# HARRISVILLE CITY

## Harrisville City Planning Commission Harrisville City Offices Wednesday, July 10, 2024

### AGENDA

TO: Harrisville City Planning Commission  
FROM: Matt Robertson, City Engineer  
**RE: HEAVENLY ROADS SUBDIVISION  
Preliminary Plat Submittal**  
Date: July 3, 2024

# GARDNER GROVE SUBDIVISION

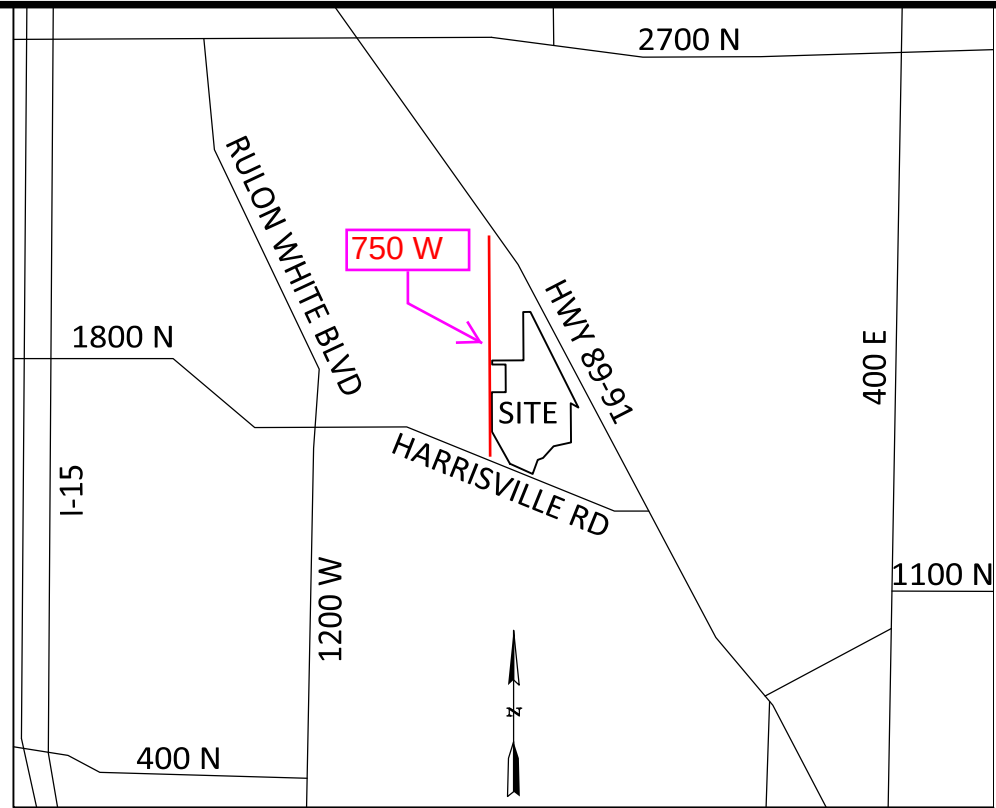
5. The proposed land swap with the Vasas family will need to be finalized and they will need to sign the plat as property owners in the subdivision.
6. Show the existing ponds and ditches and any wetland delineations on the plat.

8. Provide lot addresses on the plat as provided by our office.

DON'T CLOSE OR  
MATCH UP WITH THE  
DRAWING - REVISE  
AND UPDATE

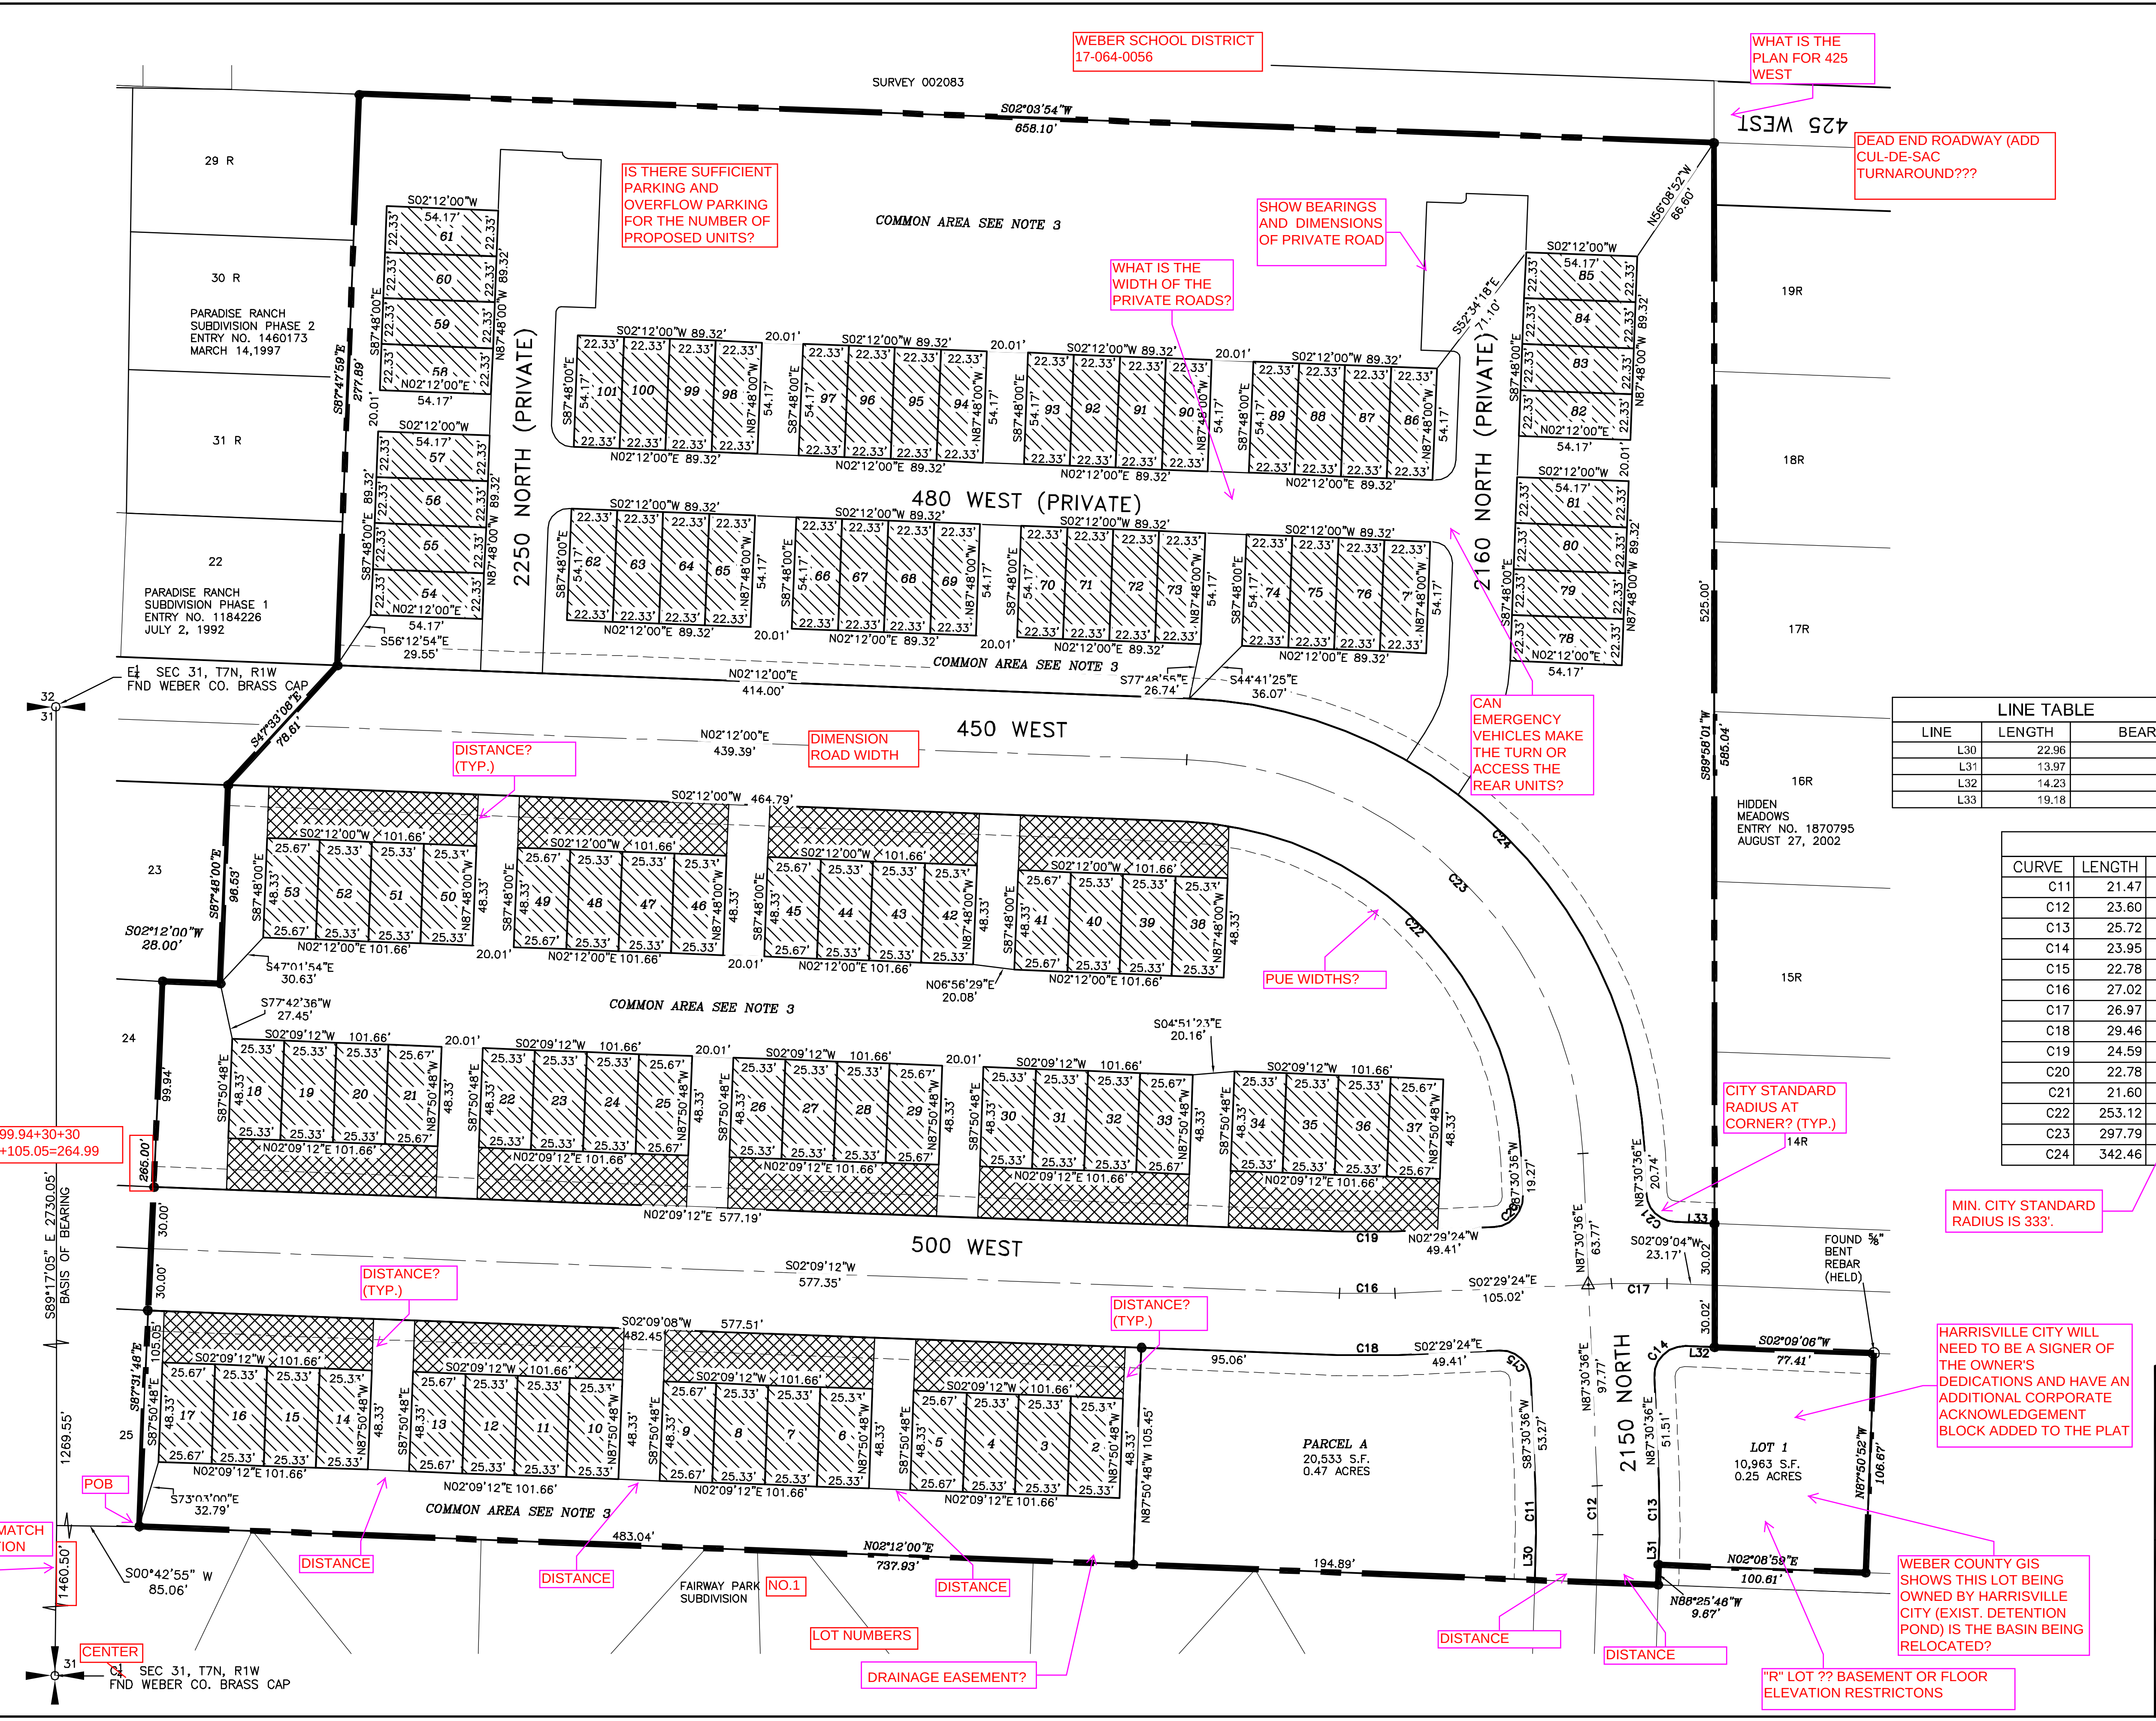
The calculations on the preliminary plat indicate a total of 11.60 acres. This discrepancy affects the number of units and available open space calculations. The Developer will need to review these parcels and make the necessary corrections to the calculations.

2. Provide information on the plat that indicates building setback requirements which are compliant with the R-3 zoning ordinance.
3. Provide information on the plat that indicate building height requirements which is compliant with the R-3 zone.
4. Based on the development density, please provide parking calculations for both tenant parking and visitor parking stalls.
5. Show on the plat proposed locations for tenant amenities. (i.e. playground, walking path/trail etc.)

HEAVENLY ROADS SUBDIVISION  
PART OF THE SOUTHEAST QUARTER OF SECTION 31  
TOWNSHIP 7 NORTH RANGE 1 WEST  
SALT LAKE BASE AND MERIDIAN  
WEBER COUNTY  
HARRISVILLE, UTAH  
**PRELIMINARY PLAT**  
NOT TO BE RECORDED

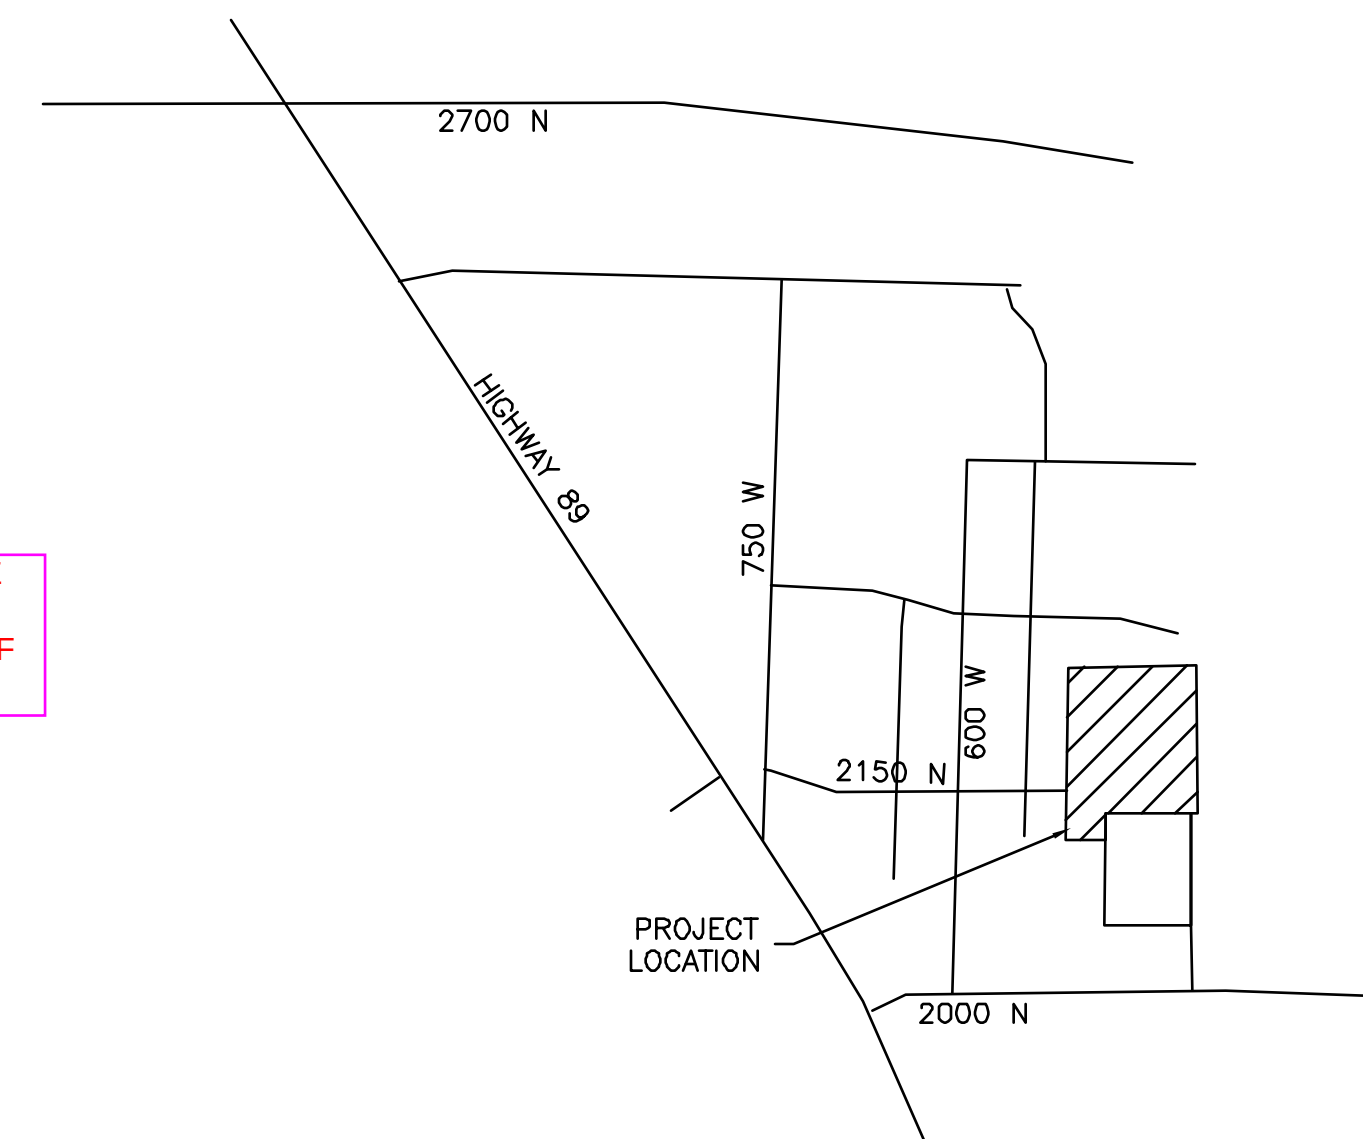
**ADD SIGNATURE BLOCK AND ACKNOWLEDGEMENT FOR HARRISVILLE CITY AS THEY ARE THE CURRENT OWNERS OF THE PROPERTY COMPRISING OF LOT 1**

Overall Site & Utility Plan For

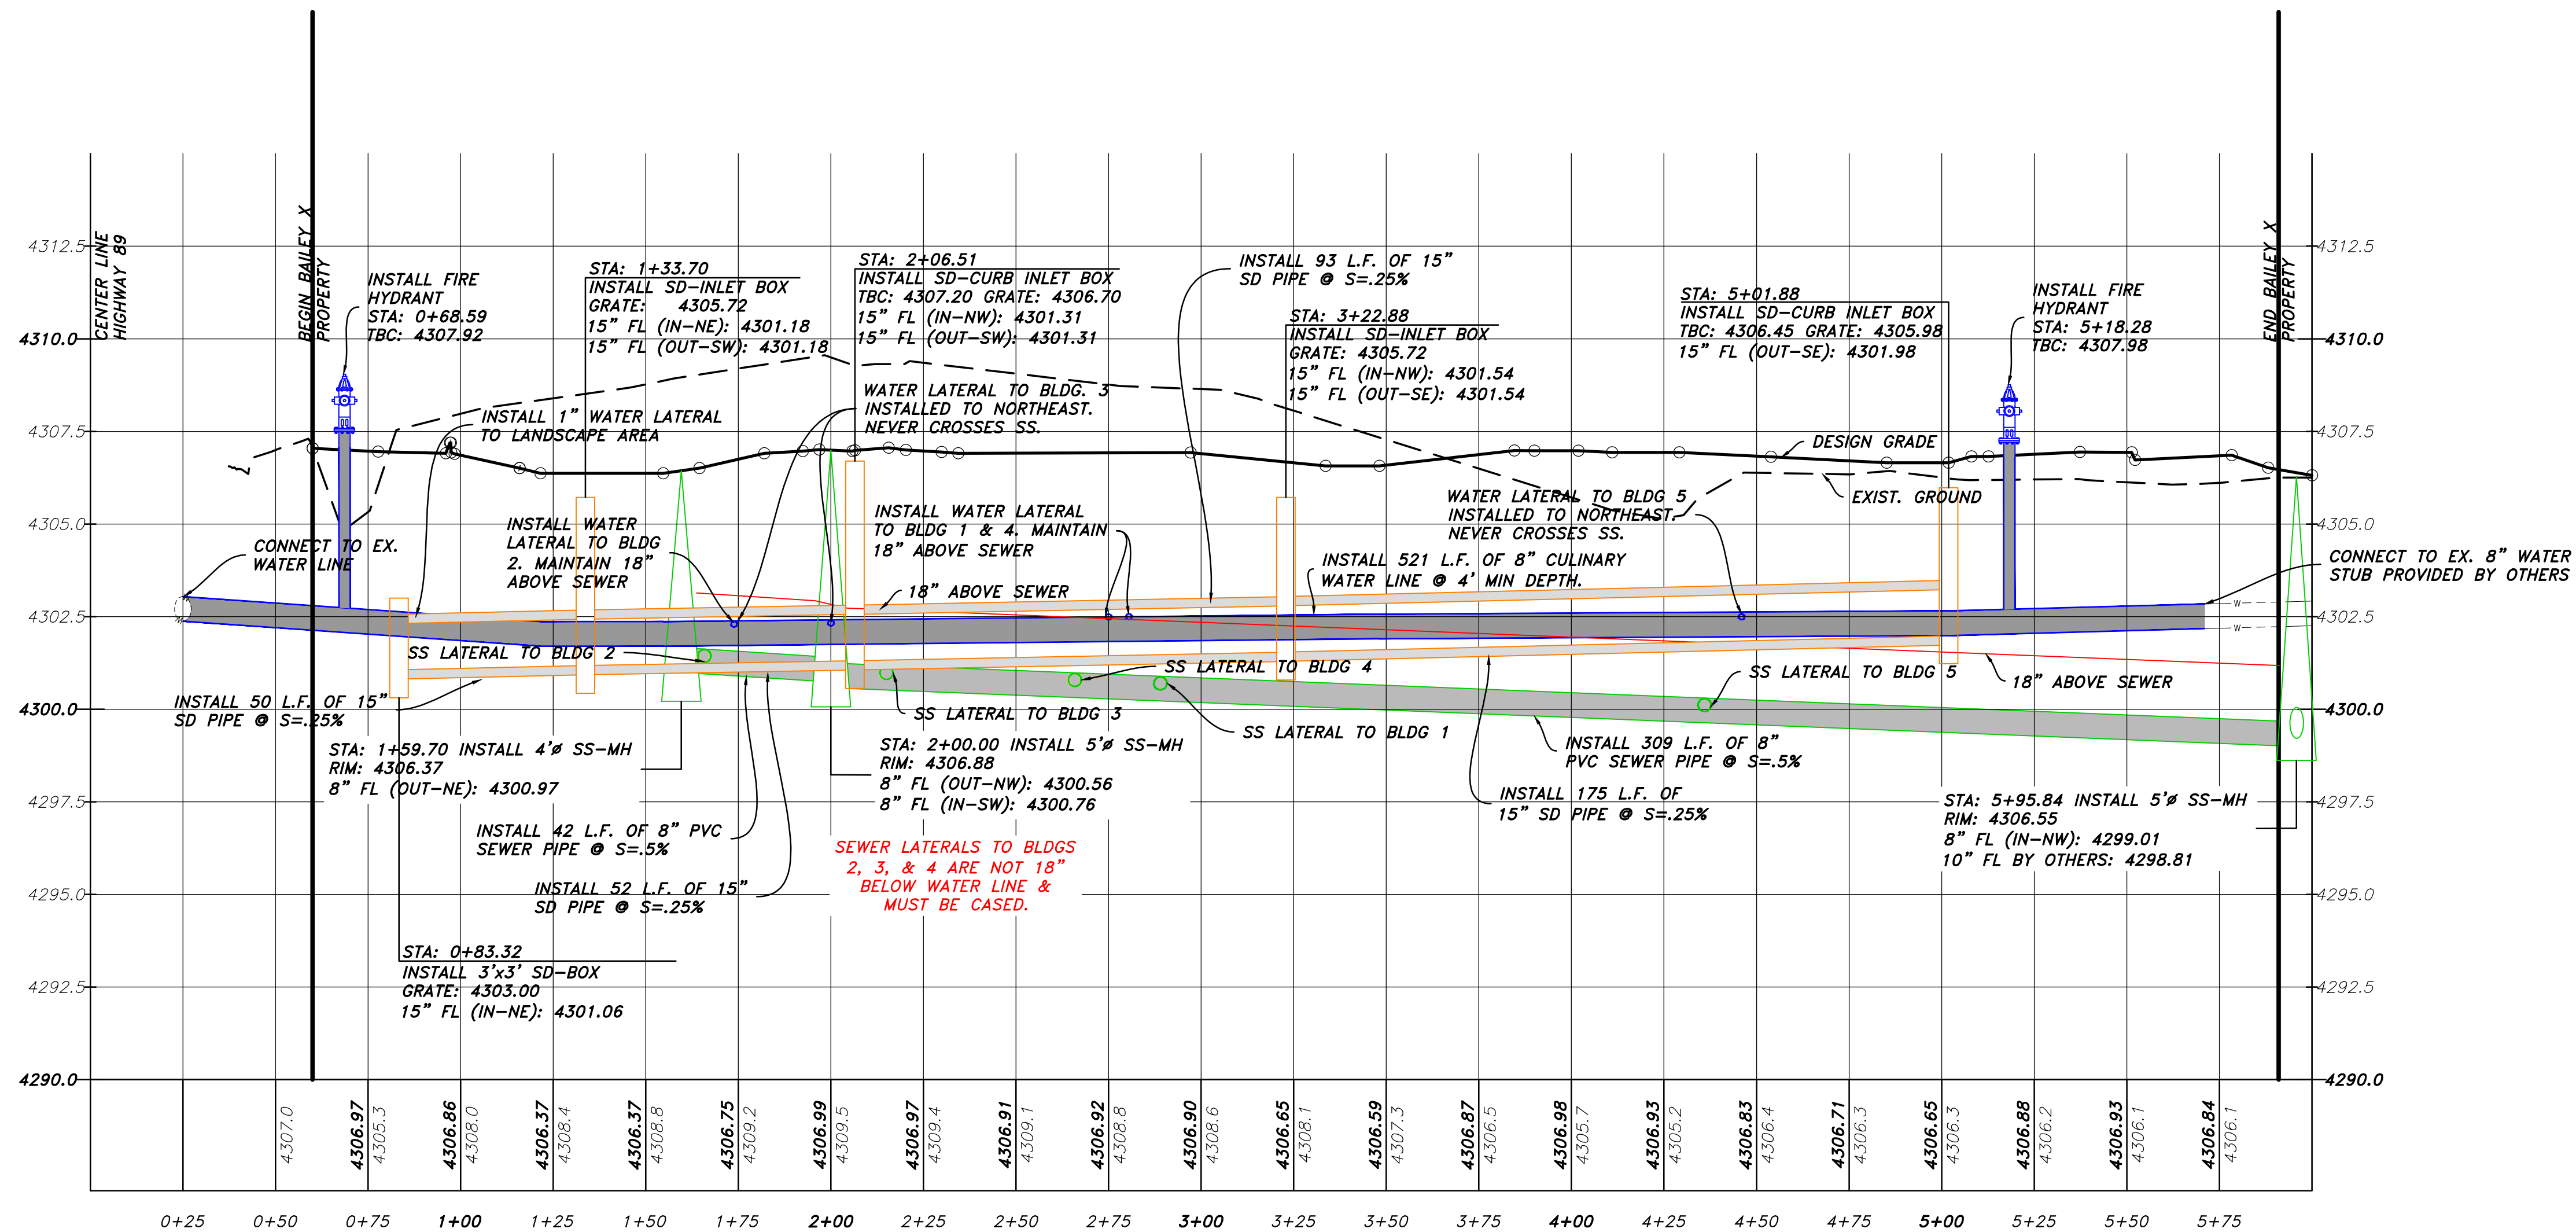
1. Record an easement at the County for the utility easement shown over the new 8" sewer that will be owned by Harrisville City.
2. Complete a Storm Water Pollution Prevention Plan (SWPPP) and file a Notice of Intent (NOI) with the State.
